Staff Report

Re: **Petition PLNHLC2018-00942 – New Construction**
Petition PLNHLC2019-00111 – Special Exception Requests

NEW CONSTRUCTION – SINGLE FAMILY HOME / ADU & SPECIAL EXCEPTION REQUESTS

PROPERTY ADDRESS: 170 W 600 N

Southeast perspective of accessory structure

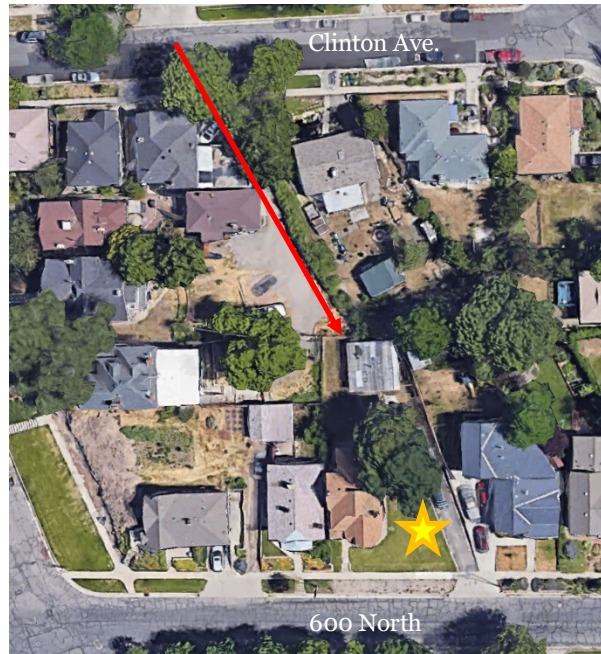
The massing of the ADU is complementary to that of the principal structure and is primarily made of one block with flat roof, with a separate shed roof form that covers the exterior stairs and entryway to the upper-level ADU, and has supports that drop down to ground level and create articulation in the front and east side façades.

The majority of the accessory structure would be clad in stucco, with some of the modulated areas created by the sloped roof form clad in Vermont slate. Proposed glazing includes sliding glass doors for the main entry that are similar to those used on the principal structure, as well as aluminum-clad windows that also have similar proportions and style, as required by the ADU ordinance.

Site plan showing four (4) proposed window wells on west elevation, and pedestrian pathway in east side yard that leads to the accessory structure

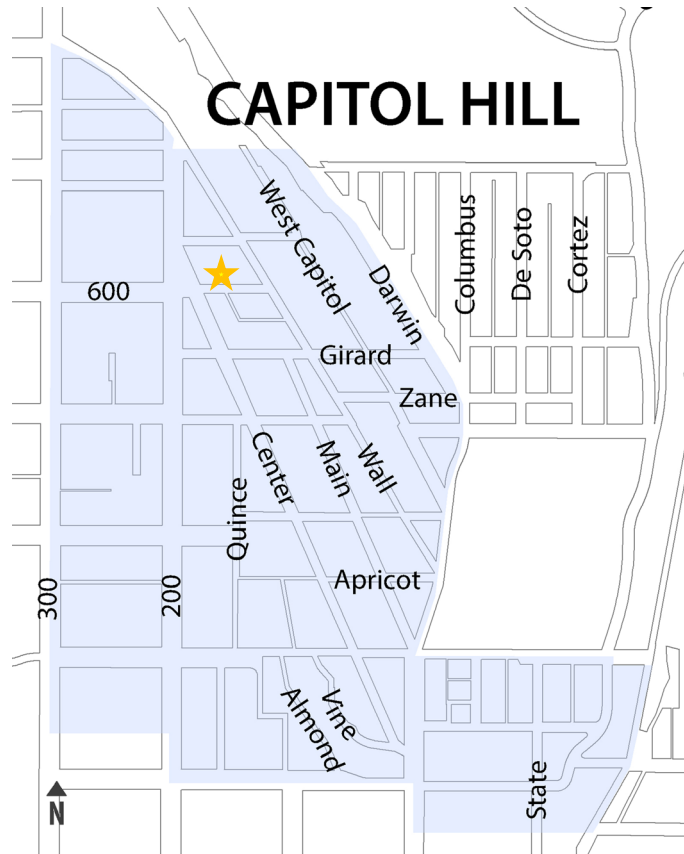
Special Exception for Wider Window Wells

The first Special Exception request is for window wells that are wider than typically permitted when located within a side yard setback area. 21A.36.020.B allows for window wells not over 6 feet (6') in width that project not more than 3 feet (3') from the structure. Submitted plans show four (4) total window wells proposed within the west side yard that project 3 feet (3') from the principal structure, and have widths of 10 feet, 9 inches (10', 9"), 4 feet, 4 inches (4', 4"), 8 feet, 5 inches (8', 5"), and 7 feet, 3 inches (7', 3").

The narrative claims that, due to site constraints, all windows for the basement level of the home have been placed on the west elevation, and the wider window wells are necessary to

provide adequate light, ventilation, and egress as required by Building Code. Staff agrees that the lot is narrow, which has resulted in reduced side yard setback requirements per Code (9 feet on the west side and 4 feet on the east side). The east side yard contains the primary pedestrian access to the accessory structure and ADU, and placing window wells near that pathway may present an unnecessary risk. If wider window wells are necessary to meet life safety requirements for the lower level of the home, Staff finds that it is preferable to place them away from the pedestrian walkway. In addition, the window wells would be sunken below grade and not readily visible from 600 North, having very minimal impact on the perceived development pattern along the block face.

1 SITE PLAN
Scale: 1/8" = 1'-0"

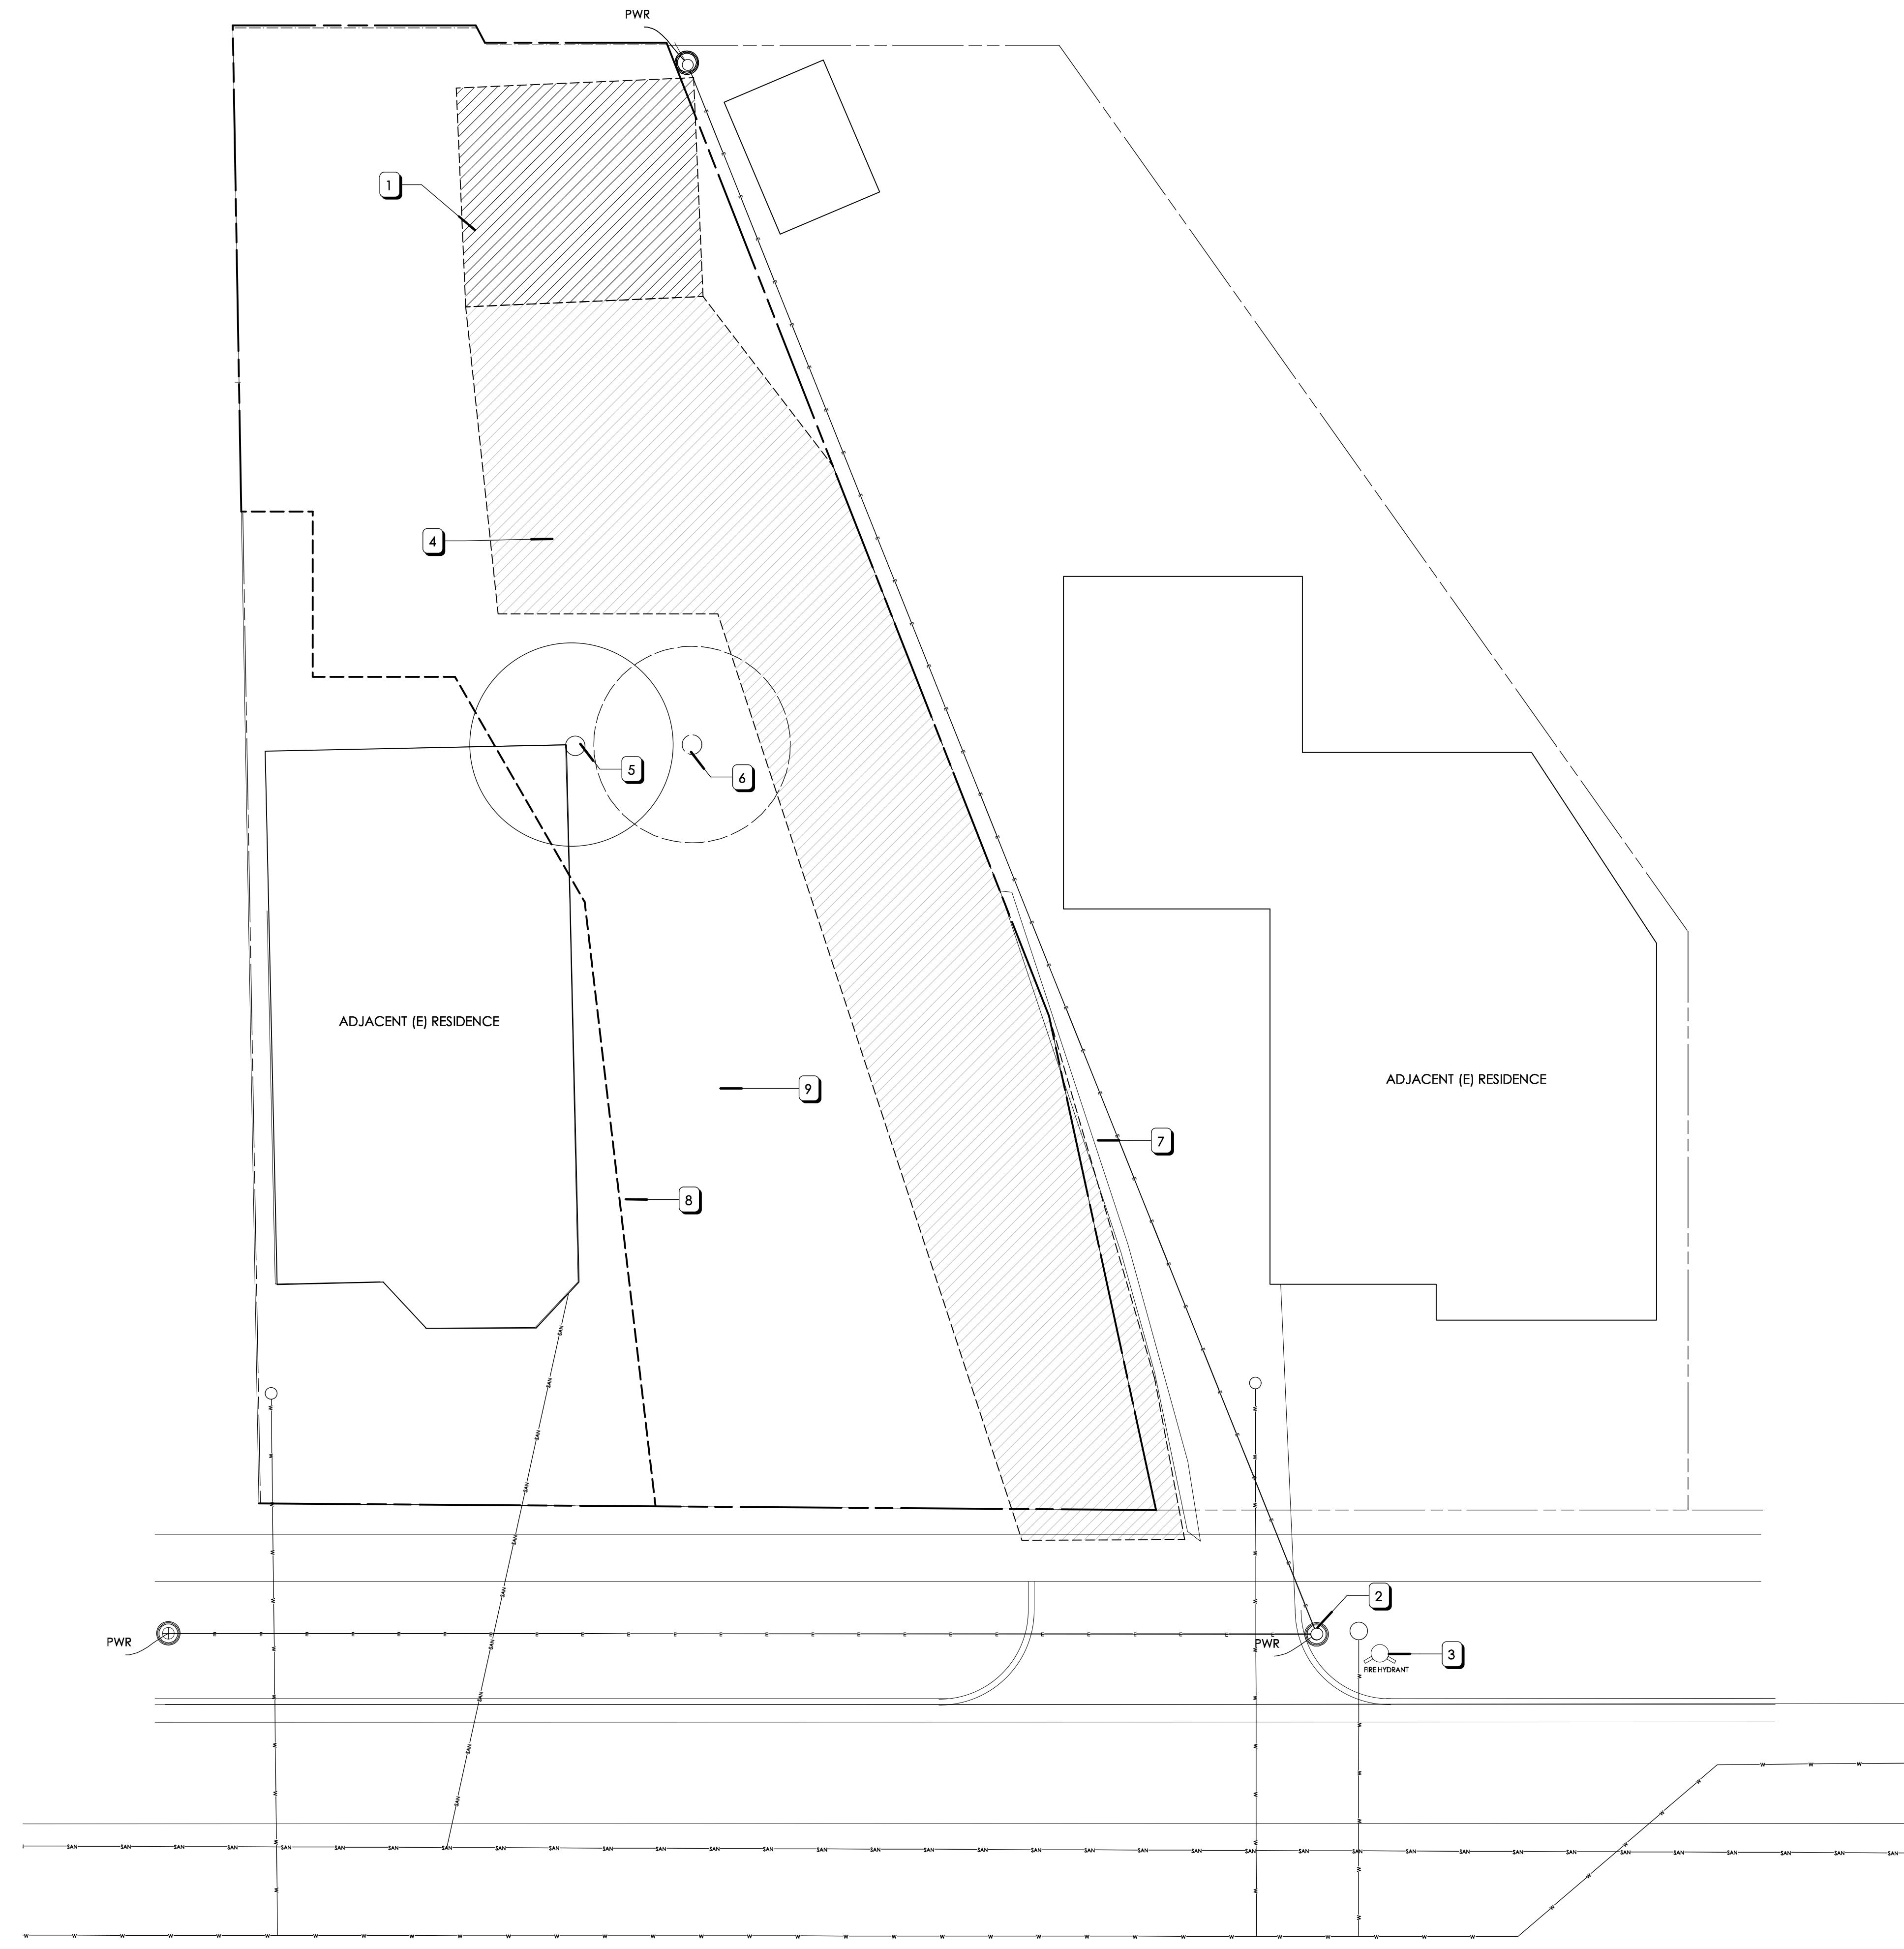
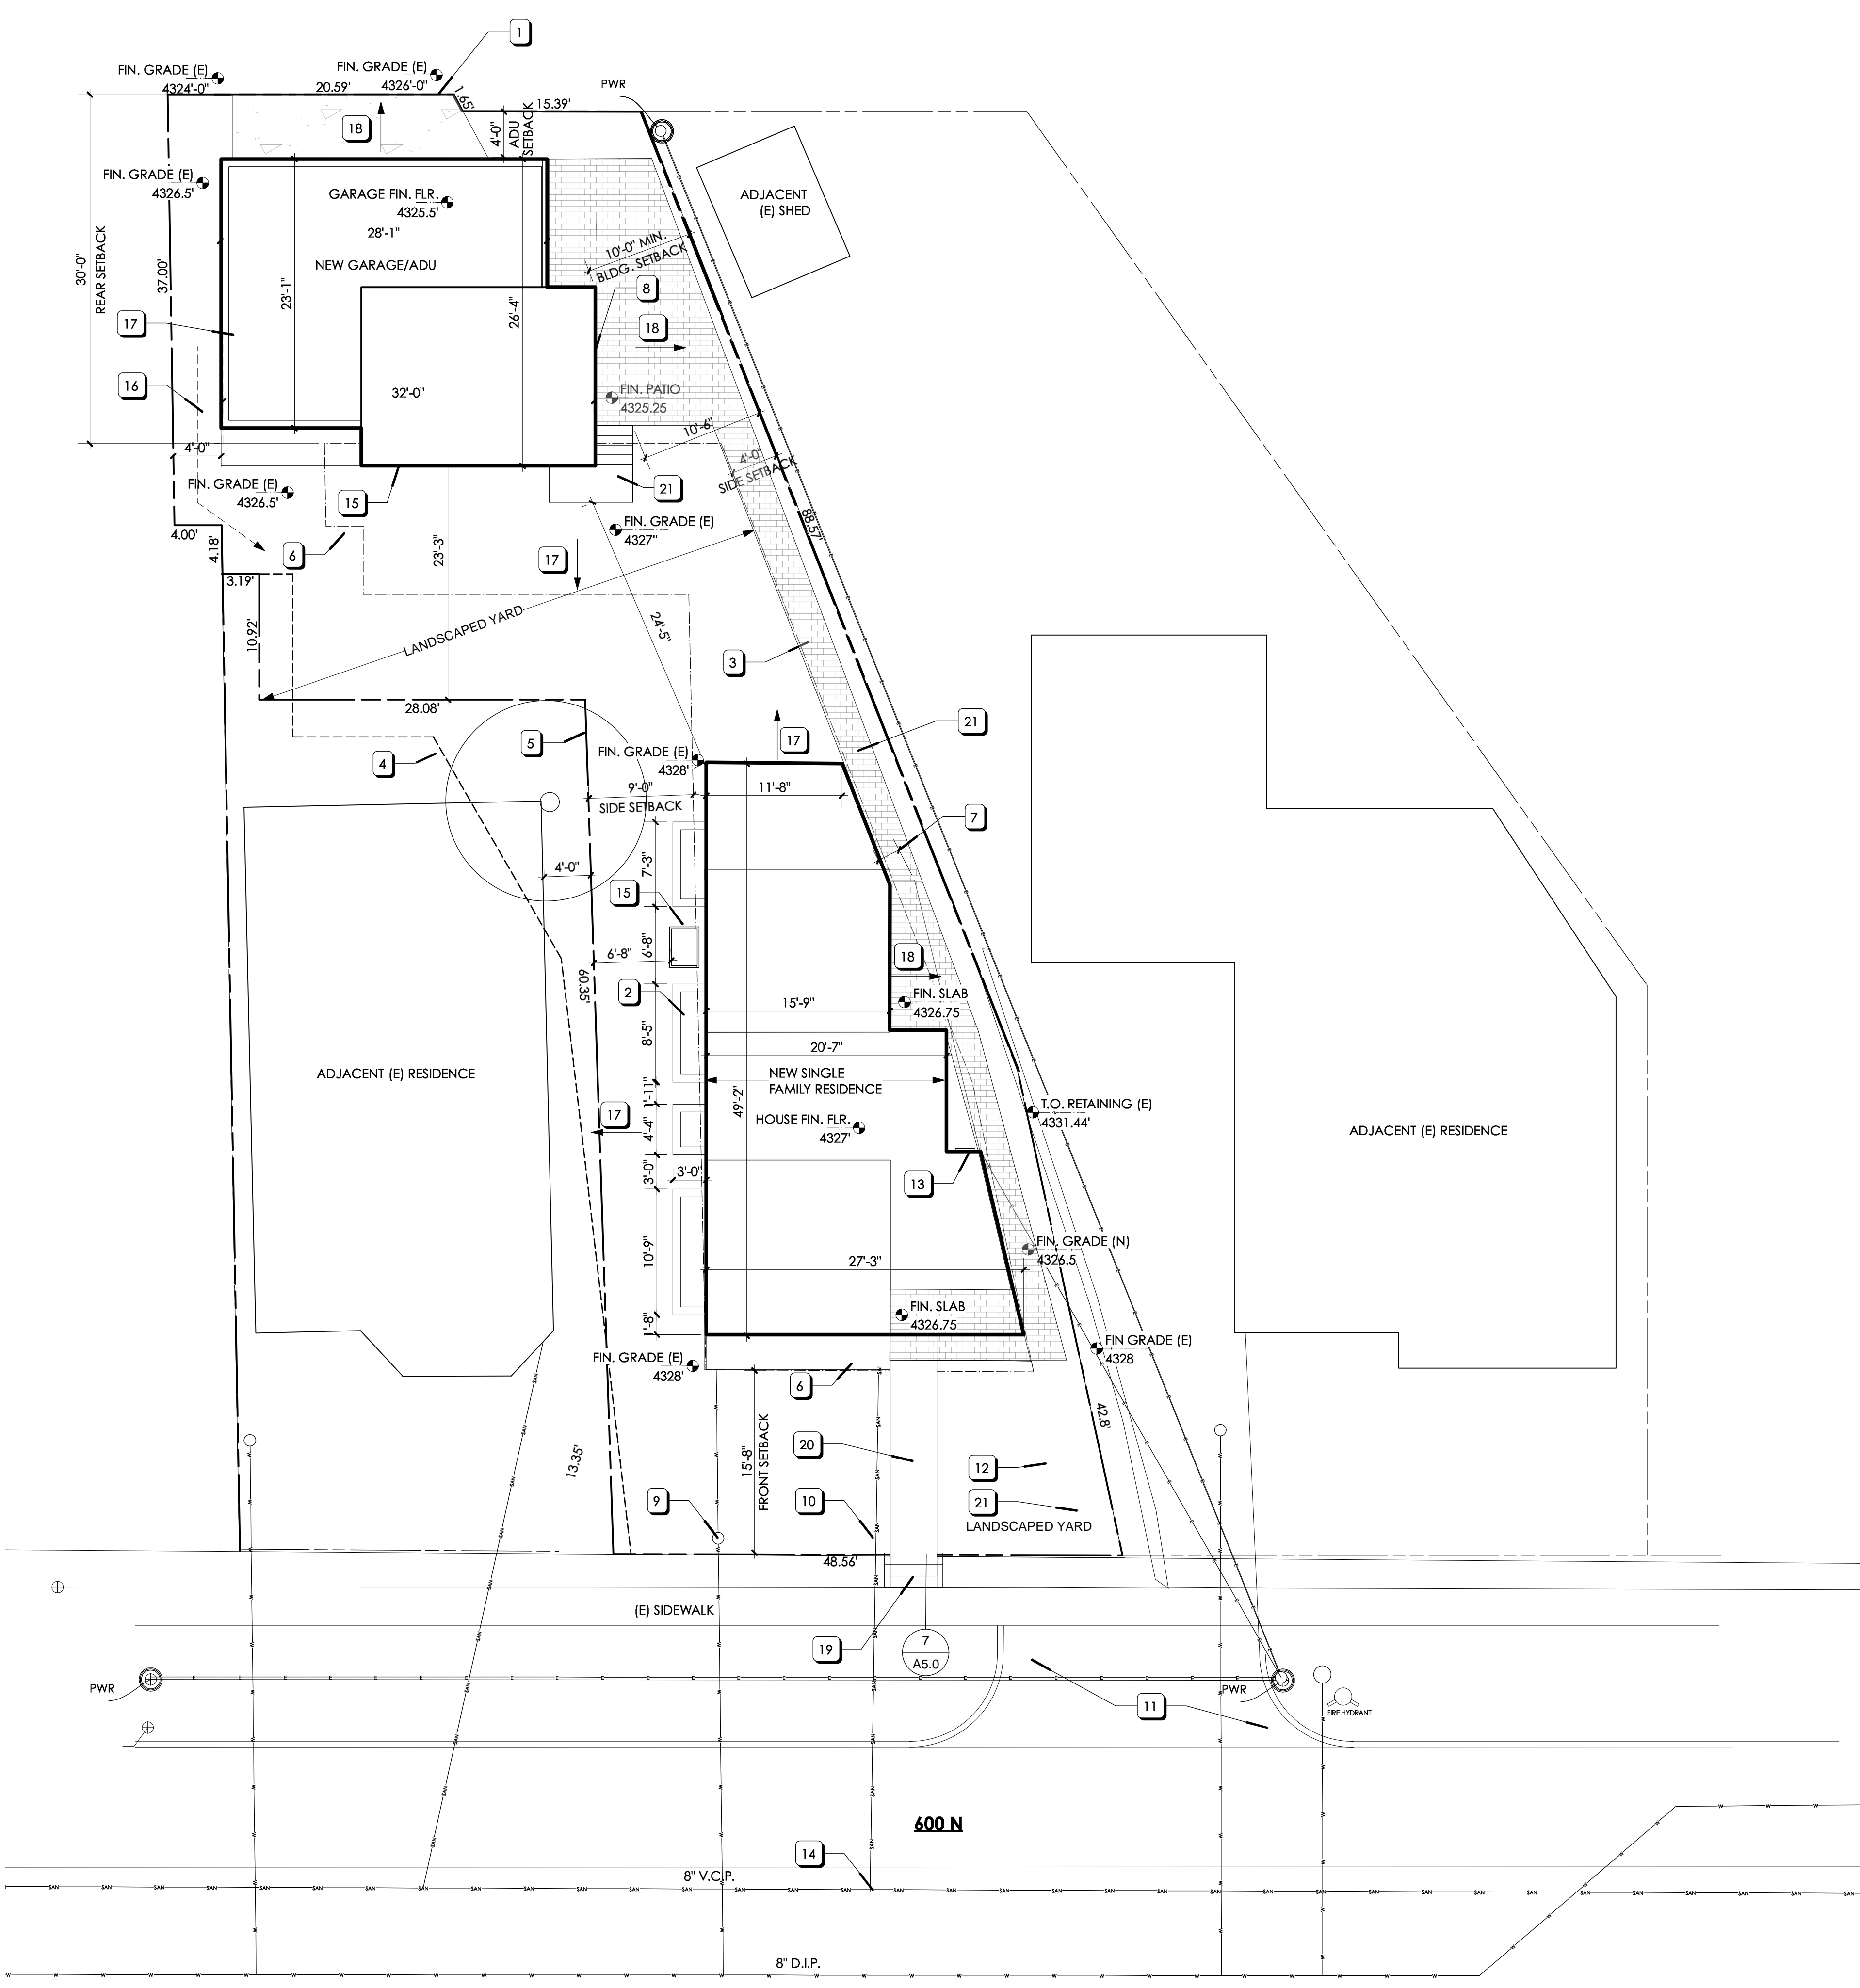
The lot boundary shown on the submitted site plan does not match up with existing conditions, but as of the publish date of this report, the applicant has been working on application materials needed to complete the necessary lot line adjustments. Staff has recommended a condition of approval that would require the applicant to complete this process before any building permits could be issued. Because the subject property has a legal noncomplying lot width, amendments could not increase the level of noncompliance, meaning that the current lot width of 42.4 feet, as well as a minimum lot area of 5,000 sf, would need to be maintained.

1. Approval of all final design details, including specific direction expressed by the Commission, shall be delegated to Planning Staff.
2. Prior to the issuance of a building permit, the applicant shall complete the Lot Line Adjustment process (through to recordation) so the parcel's lot lines reflect what is shown on the submitted site plan. The following must be met:

- a. Adjustments made to 170 West 600 North (subject parcel) shall result in a minimum lot size of at least 5,000 sf and a lot width that is not less than 42.4 feet (measured at the front yard setback line of 15 feet, 8 inches (15', 8")).
